Number: TAB-09-013

ALEXOR V1.02 Software Release

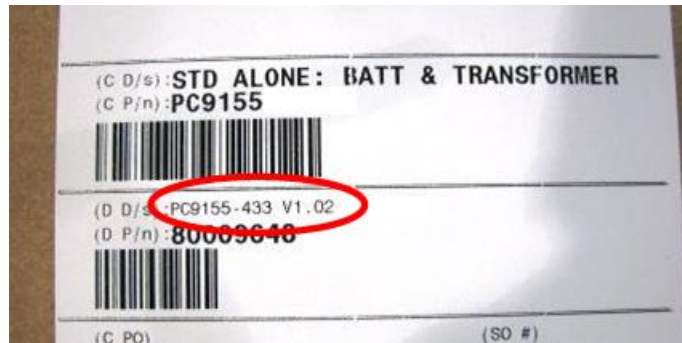
Please be advised that the ALEXOR PC9155 control panel software version has been upgraded from V1.01 to V1.02. The new V1.02 software supports a revision to the Contact ID identifier for the Partial Closing reporting code.

Section [382] Option [1] – The 'Contact ID Partial Closing Identifier is 4/5' toggle option has been removed from the control panel. This feature is now hardcoded OFF so that the PC9155 will always transmit a '4' as the Contact ID identifier for the Partial Closing reporting code.
